SECTION 221 : CONSENT NOTICE

REGARDING RC 2030509

PROPOSED SUBDIVISION OF LOTS 4 & 5, DP 56174,
FORESHORE ROAD, AHIPARA

Re **MELVILLE HOLDINGS AHIKARA
PROPOSED CHANGES TO ENGINEERING DETAILS**

Proposed Stormwater Reticulation
Layout

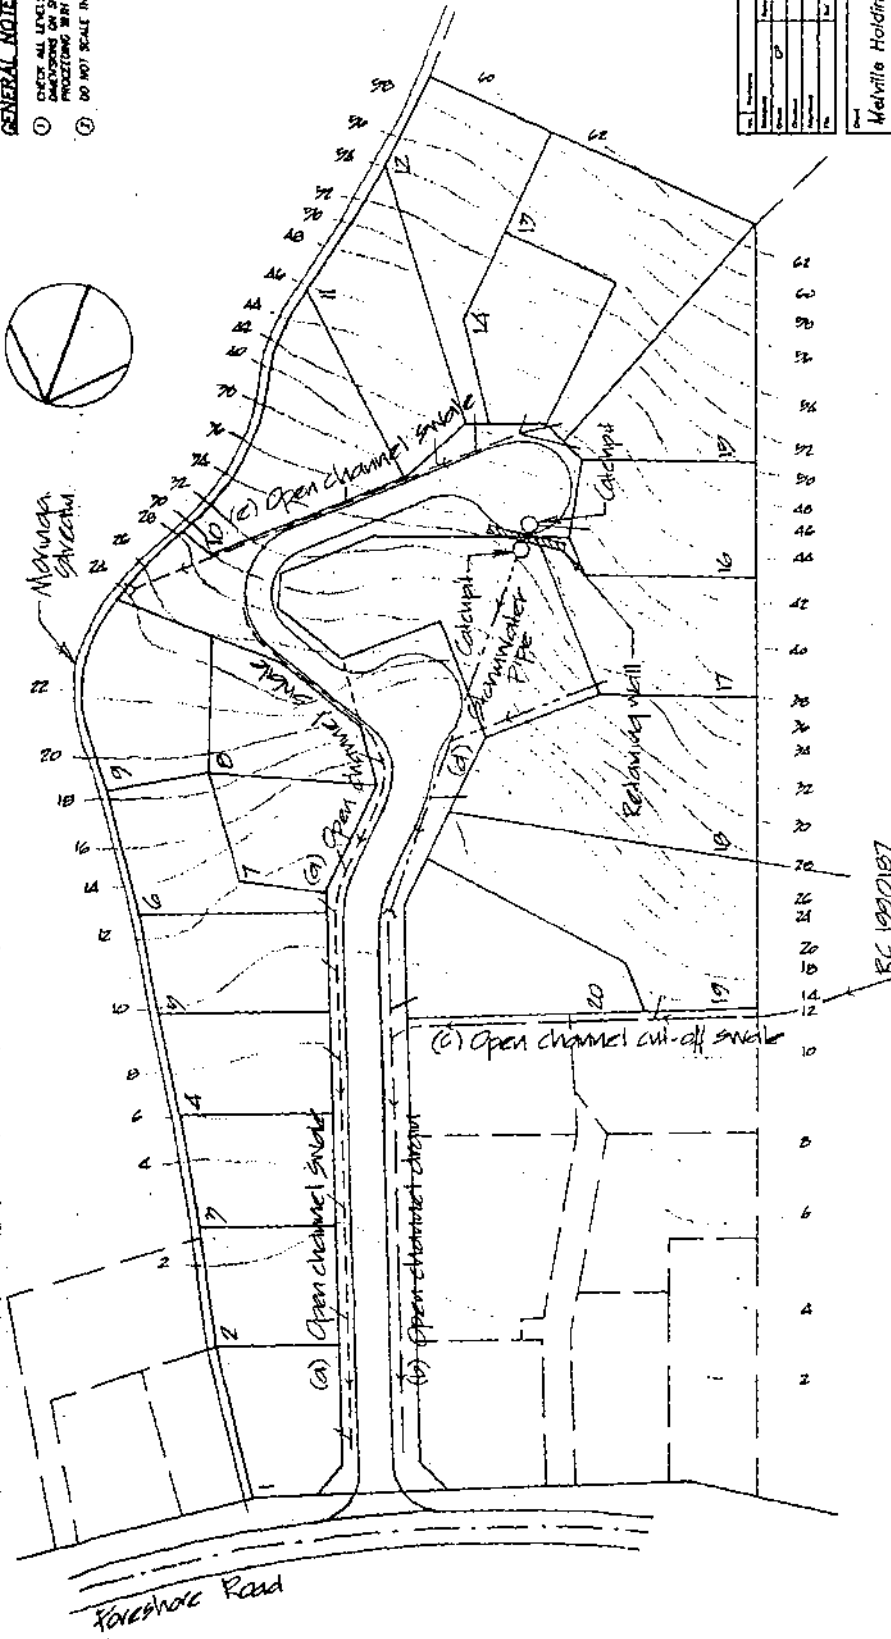
Box Culvert

The box culvert will now be installed on the Moringai Stream. All stormwater discharge from the proposed subdivision will be diverted into this culvert. The existing culvert on the Moringai Stream is undersized and cannot cope with existing discharges, hence the liability of flooding currently experienced. The existing 450 mm diameter culvert at the end of the proposed subdivision road will remain as is.

Swale Drains

It is not our intention to install swale drains on any gradients steeper than 1:20. Nor is it our intention to encumber the Far North District Council with a maintenance / mowing problem. We therefore confirm that all swale drains indicated on the submitted stormwater management plan are to be replaced with piped systems. Overland flow paths will be formed directly above the pipe runs where appropriate, by dished depressions in the road verge.
